North Anna Units 1 and 2

NRC RAI: See Comment Number 3.6.1-1. Comment: See Comment Number 3.6.1-1.

3.6.3 Containment Isolation Valves

25.	DOC L.6
(3.6.3-9)	CTS 4.6.1.1.a and Associated* Footnote
	ITS SR 3.6.3.2 and Associated Bases

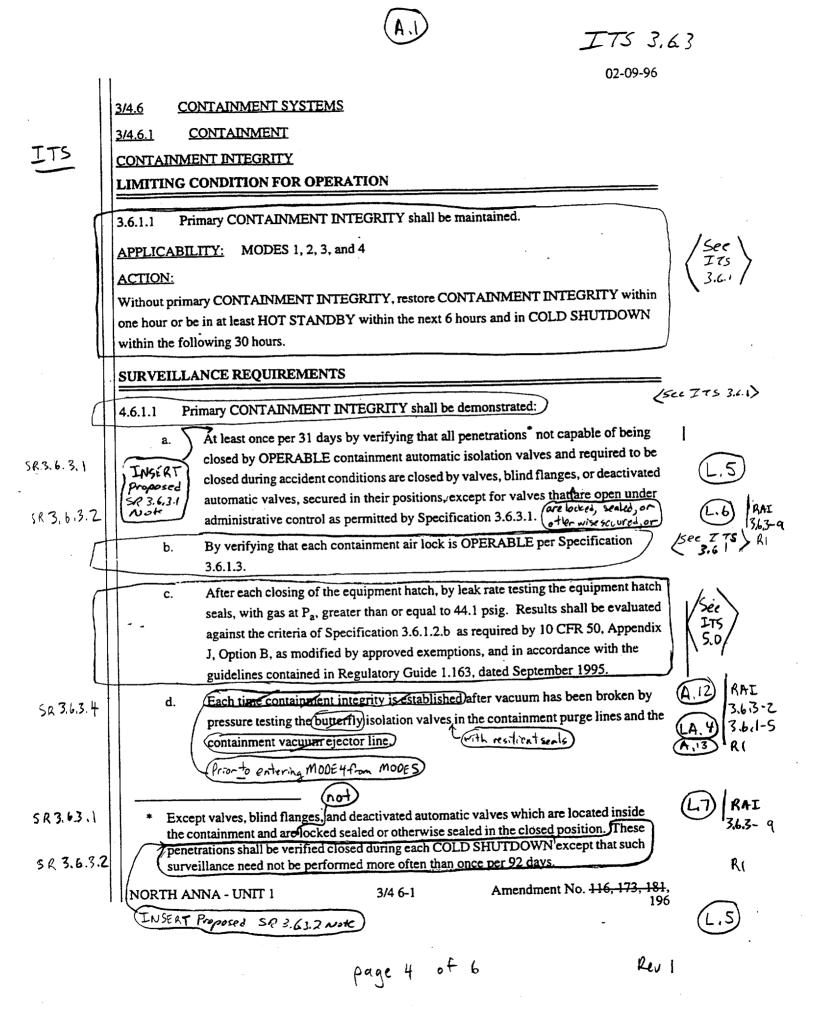
NRC RAI: CTS 4.6.1.1.a verifies that all primary containment penetrations not capable of being closed by OPERABLE automatic isolation valves and required to be closed during accident conditions are closed by valves, blind flanges, or deactivated automatic valves secured in their closed position on a 31-day frequency except valves that are locked, sealed or otherwise secured in the closed position and are inside containment. These valves are verified during COLD SHUTDOWN except such verification need not be performed more often than once every 92 days. The corresponding ITS SR for this CTS surveillance (valves inside containment) is ITS SR 3.6.3.2. DOC L.6 justifies adding the "locked, sealed..." or otherwise secured requirement to CTS 4.6.1.1.a, but does not discuss or justify changing the associated *Footnote requirement from verifying the locked, sealed, or otherwise secured valves closed to not locked, sealed or otherwise secured and the change in frequency from 31 days for valves inside containment that are not locked, sealed or otherwise secured in the closed position to the CTS/ITS frequency of "prior to entering MODE 2...previous 92 days." This change is a less Restrictive (L) change. Comment: Provide additional discussion and justification for this Less Restrictive (L) change.

Response: The Company will take the action proposed in the Comment. The CTS markup is modified, and DOC L.7 added to address this change.

TTS 3.6.3

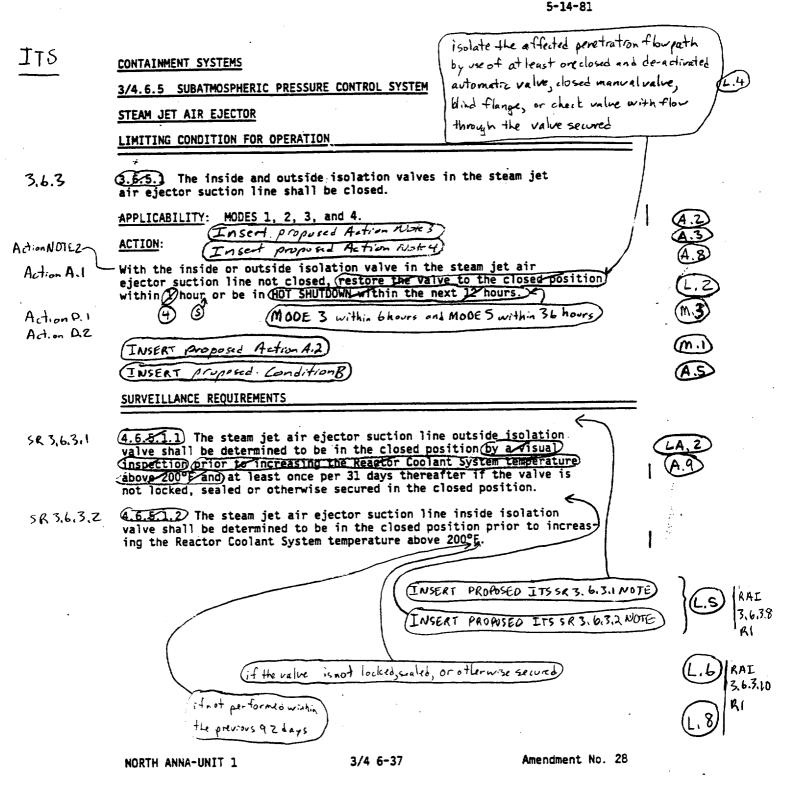
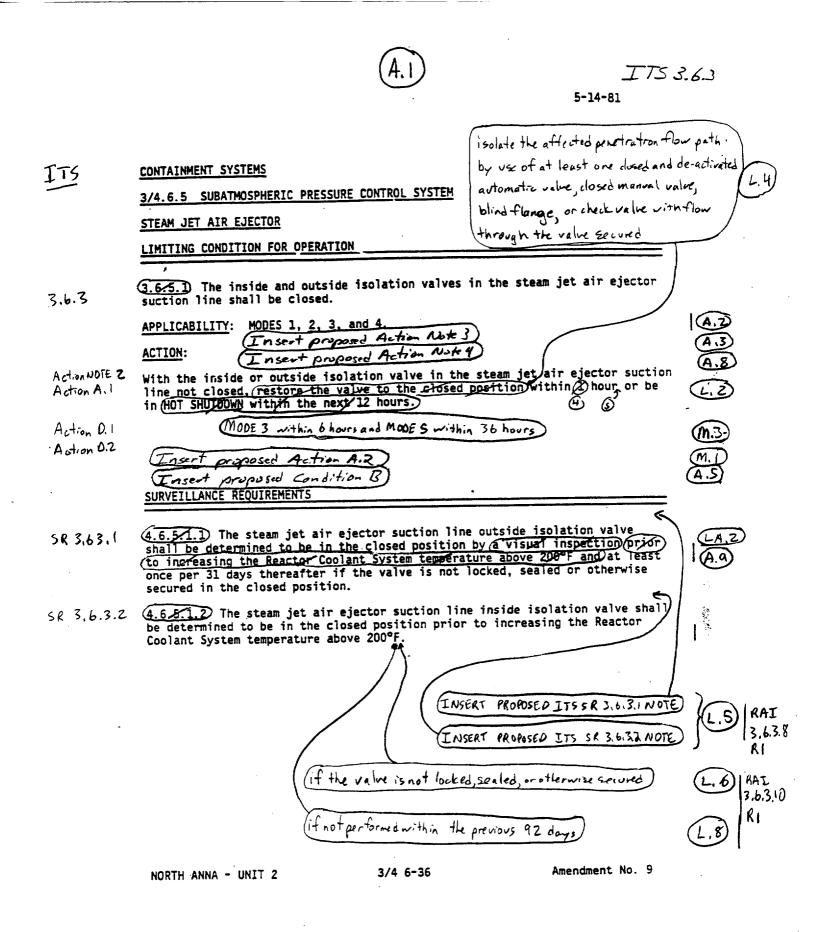
NRC RAI: CTS 4.6.5.1.2 verifies that the steam jet air ejector suction line isolation valves inside containment are closed prior to increasing the RCS temperature above 200 □F. The corresponding ITS SR based on the assumption that these valves are manual valves (Refer to Comment Number 3.6.3-8) is ITS SR 3.6.3.2. ITS SR 3.6.3.2 verifies that manual containment isolation valves inside containment that are required to be closed are closed prior to entering MODE 4 from MODE 5 if not performed within the previous 92 days except for valves that locked, sealed or otherwise secured. The CTS markup does not modify CTS 4.6.5.1.2 to show the Less Restrictive (L) changes to the frequency (Prior to entering MODE 4 from MODE 5 to prior to entering MODE 4 from MODE 5 if not performed within previous 92 days) and exempting locked, sealed or otherwise secured valves. DOC L.6 provides some of this discussion and justification but only for CTS 4.6.1.1.a. Refer to Comment Number 3.6.3-10. Comment: Revise the CTS markup and provide the appropriate discussions and justifications for these Less Restrictive (L) changes.

Response: The Company will take the action proposed in the Comment. The CTS markup and DOC L.6 are changed to address the exemption, and DOC L.8 is added to address the Frequency change.

27. (3.6.3-11) JFD 3 Bases JFD 2 CTS 4.6.3.1.2.c CTS 4.6.3.1.2.d STS SR 3.6.3.1, SR 3.6.3.2 and Associated Bases ITS 3.6.3 ACTION Note 1, SR 3.6.3.1, SR 3.6.3.2, SR 3.6.3.5 and Associated Bases

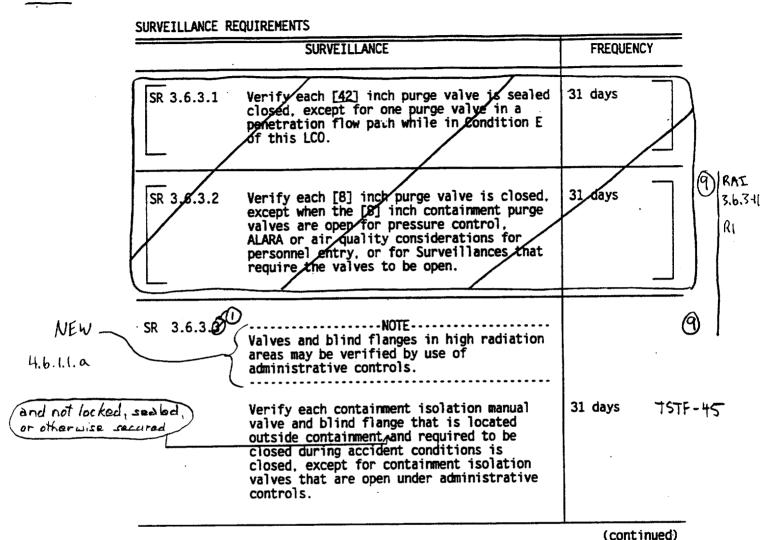
NRC RAI: STS SR 3.6.3.1 and SR 3.6.3.2 verify that the containment purge valves are either sealed closed or closed, respectively, and allowed to be opened under specific conditions. The ITS markup of ITS 3.6.3 does not include these two STS SRs. The iustification used to delete these SRs (JFD 3) states that the purge valves are not opened in MODES 1, 2, 3, or 4, "and the CTS treats the purge valves in the same manner as other containment isolation valves." The staff concludes that some form of STS SR 3.6.3.1 or SR 3.6.3.2 needs to be included in ITS 3.6.3. This is based on a number of items. The staff cannot determine from the CTS, the ITS Bases, or the JFD discussions if all the containment purge valves are automatic, power-operated or manual. Based on CTS 4.6.3.1.2.c and CTS 4.6.3.1.2.d, and ITS B3.6.3 Bases -LCO, one could conclude that the 36-inch purge valves and the 18-inch containment vacuum breaking valves are considered automatic valves. Refer to Comment Number 3.6.3-13 for concerns with regards to check valves and spring load check valves. It is not clear for the 8-inch purge bypass valves. If the purge valves are manual, then ITS SR 3.6.3.1 and SR 3.6.3.2 will verify closure. If they are automatic there is no verification of valve closure. ITS SR 3.6.3.5 only verifies that the vacuum breaking valves open and close on pressure differential on an 18-month basis and does not verify closure during operation. In addition, ITS 3.6.3 ACTIONS Note 1 allows containment penetrations to be unisolated intermittently under administrative controls except for the 36-inch purge and exhaust valves, 18-inch containment vacuum breaking valves, and the 8-inch purge bypass valve. The ITS note as written and without the appropriate SRs would allow these valves to be opened indefinitely. Thus, the staff requires the SRs be proposed to verify valve closure for these valves. Depending on the resolution of Comment Number 3.6.3-8, this concern will also apply to the steam jet air ejector suction line valves. Comment: Revise the CTS/ITS markups to include STS SR 3.6.3.1, SR 3.6.3.2 or a modification of these SRs to reflect plant-specific criteria and provide the appropriate discussions and justifications for these changes.

Response: The Company does not agree with the action recommended in the Comment. The ISTS markup is modified and JFD 9 is added to substitute for JFD 3 to describe not adopting ISTS SR 3.6.3.1 and SR 3.6.3.2.

The containment at NAPS is a subatmospheric containment. The Containment Purge and Exhaust valves are secured closed in MODES 1, 2, 3, and 4. The ACTIONS Note 1 prevents them from being opened intermittently during operation, they are excluded from that allowance. The valves are power operated. They are not automatic in MODES 1, 2, 3, or 4. Adding the restriction to the CTS is addressed by DOC M.2. This is also explained in an addition to the Bases Background, where we say, deleting the word "normally", "The 36 inch purge valves are maintained closed in MODES 1, 2, 3, and 4 to ensure the containment boundary is maintained. The 18 inch containment vacuum breaking valve and 8 inch purge bypass valve are also maintained closed in MODES 1, 2, 3, and 4." These references together make it clear that the valves are required to be closed, and if not secured, verified every 31 days. They are treated like any other power operated, non-automatic valve, except that they may not be opened. The ISTS 3.6.3.1 Bases also refer to a capability to automatically close, and ISTS SR 3.6.3.2 refers to the ability to open the minipurge valves. Neither of these applies at North Anna. None of the purge and exhaust isolation valves are capable of automatically closing in MODES 1, 2, 3, and 4. Besides all that, if they were open, the unit would have to be shutdown based on the Containment Pressure LCO (one hour action statement) because the containment is subatmospheric.

13.	DOC L.5
(3.6.2-7)	CTS 4.6.1.3.a
	ITS 5.5.15.f

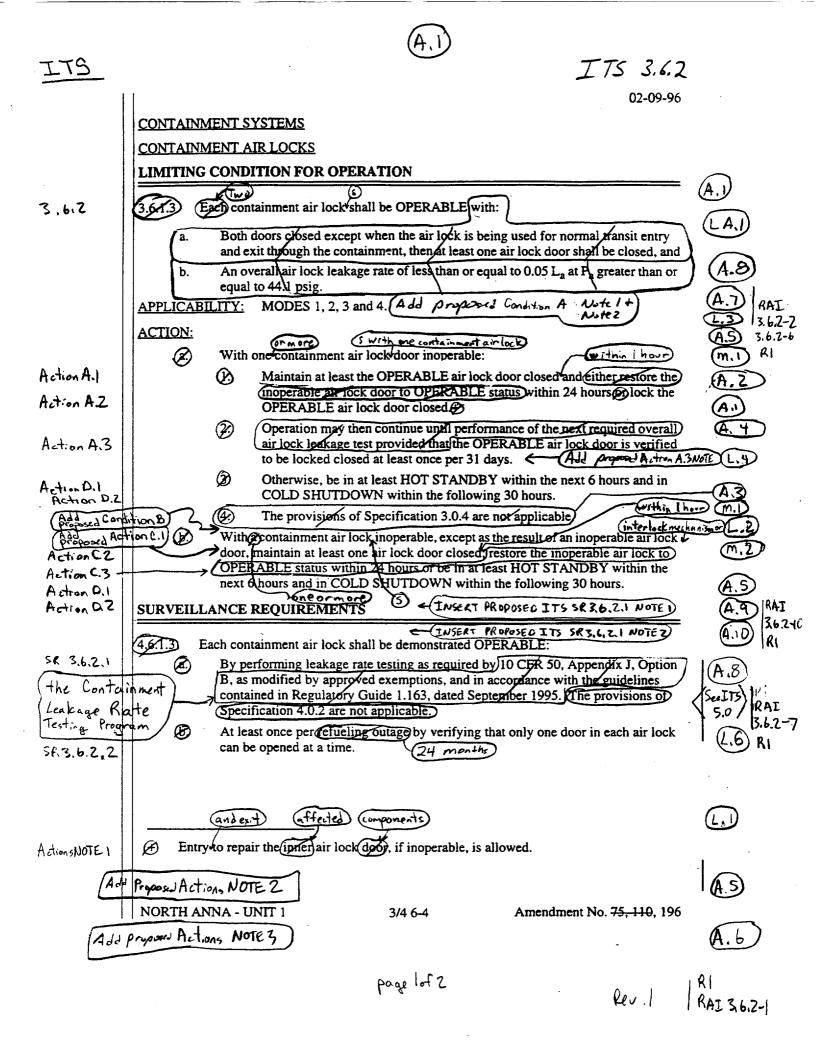
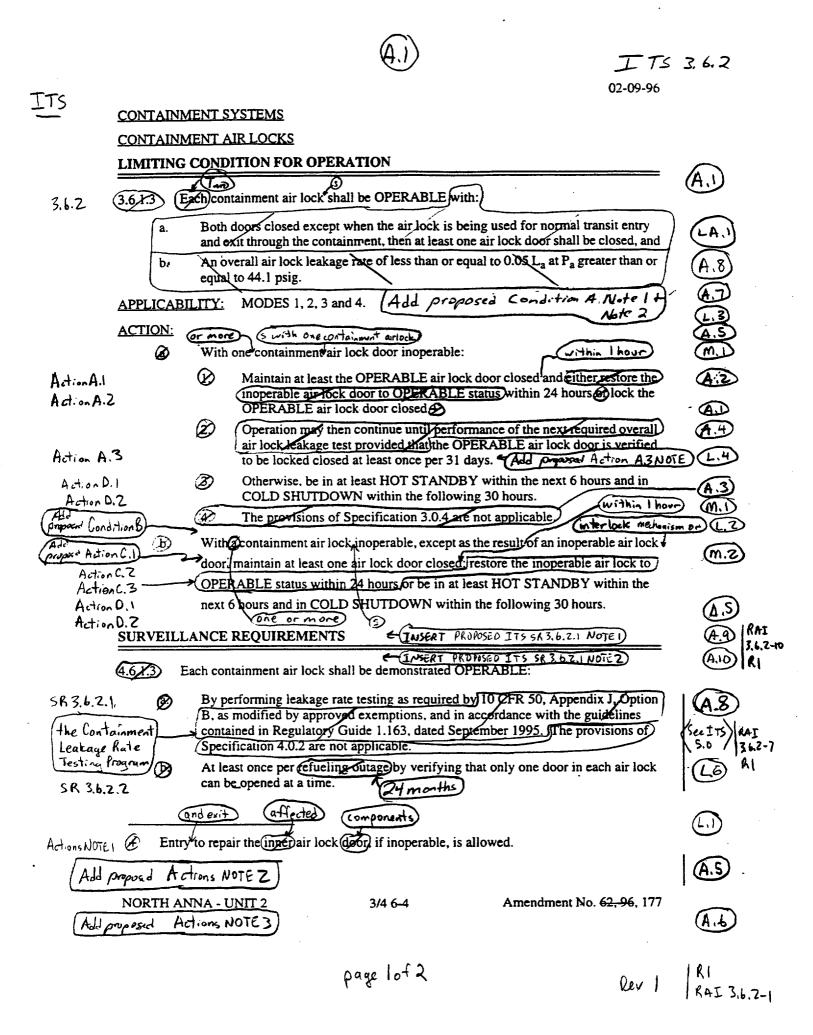
NRC RAI: CTS 4.6.1.3.a states that "The provisions of specification 4.0.2 are not applicable." The CTS markup of CTS 4.6.1.3.a shows this statement as being deleted by DOC L.5. DOC L.5 states this change allows ITS SR 3.0.2 to be applied to ITS SR 3.6.2.1. This is incorrect. The surveillance frequency for CTS 4.6.1.3.a and its corresponding ITS SR 3.6.2.1 are governed by the requirements of the Containment Leakage Rate Testing Program and 10 CFR 50 Appendix J, Option B. Thus the provisions of CTS 4.0.2/ITS SR 3.0.2 are not applicable. This is specified in ITS 5.5.15.f, which states that "Nothing in these Technical Specifications shall be construed to modify the testing Frequencies required by 10 CFR 50 Appendix J." This ITS statement and the CTS statement in CTS 4.6.1.3.a are the equivalent as agreed to in the development of TSTF-52 Rev. 3. Thus the change would be an Administrative change in moving the statement from CTS 4.6.1.3.a to ITS 5.5.15.f. **Comment:** Revise the CTS markup and provide a discussion and justification for this Administrative change.

Response: The Company will take the action proposed in the Comment, with certain modifications. The existing DOC L.5 is deleted, and the subject sentence is addressed in ITS Section 5.0.

ITS 3.6.5

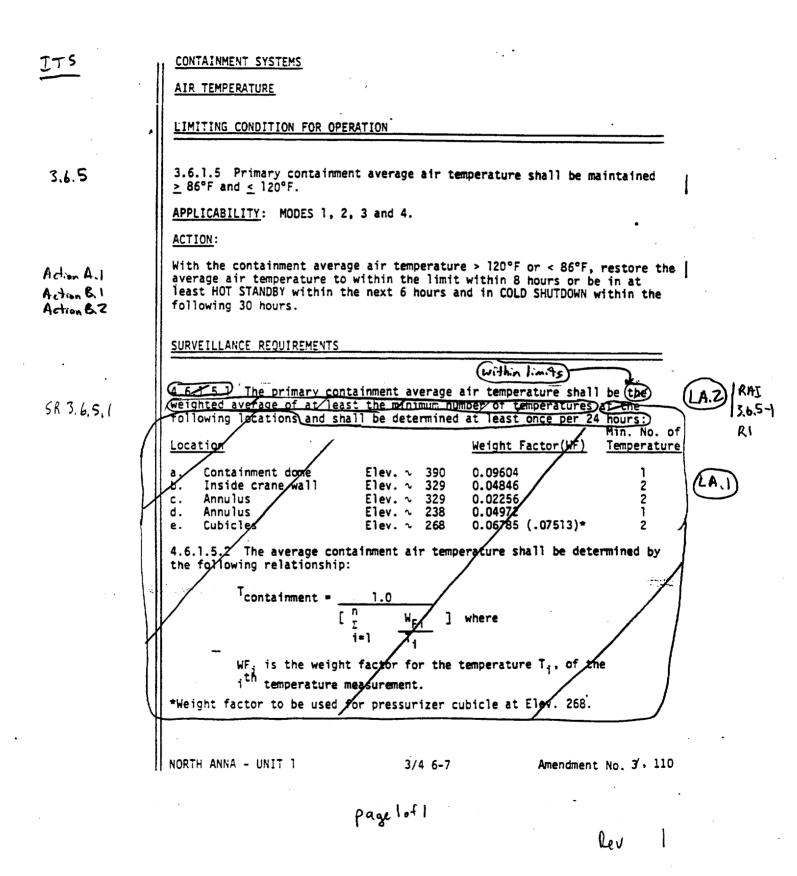
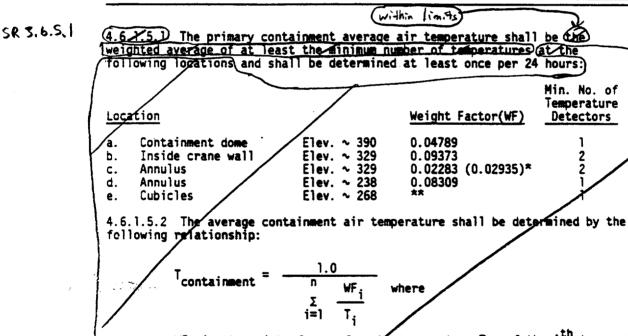
NRC RAI: CTS 4.6.1.5.1 includes specific locations where containment temperatures are to be measured and describes how the temperature used for the LCO is calculated. The CTS is modified by DOC LA.1 to relocate this information to the UFSAR. This is not entirely correct. Part of this information has been relocated to ITS B3.6.5 Bases - SR 3.6.5.1. The part that has been relocated deals with how the containment temperature is calculated - "weighted average of at least the minimum number of temperatures." **Comment:** Revise DOC LA.1 to reflect that how the temperature is calculated is also relocated to the Bases.

Response: The Company will take the action proposed in the Comment. The CTS markup and DOC LA.1 are modified, and DOC LA.2 is added, to address movement of the requirement to determine containment temperature based on a weighted average of at least the minimum number of temperatures to the Bases.
